DBIM pricing method for 8X expansion

Submission from Selected Users

June 2021

Figure 1 Unit cost under different modelling assumptions (Synergies modelling) – 10 year average \$/t

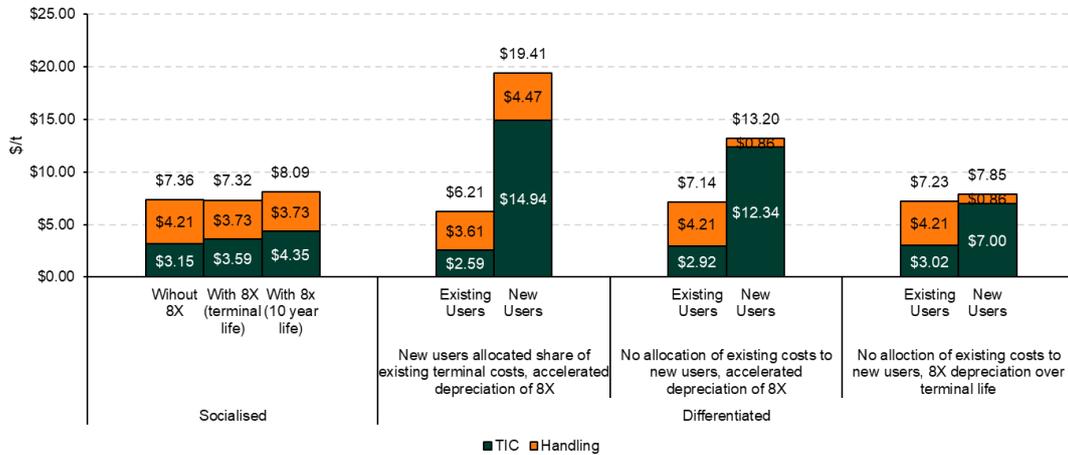
This comparison indicates that Synergies’ high level results are sufficiently robust to enable testing of alternate modelling assumptions. Figure 1 then shows average modelled unit costs over the ten years from 2028 to 2037, but adjusting the costing methodology to reflect a more conventional application of the ‘averaging down/incremental up’ principle. For consistency, these modelled unit costs continue to use DBIM’s input cost and fully contracted volume assumptions, however this does not imply acceptance of these assumptions by Submitting Users and it is noted that actual unit costs may vary significantly from this due to cost or volume variations.
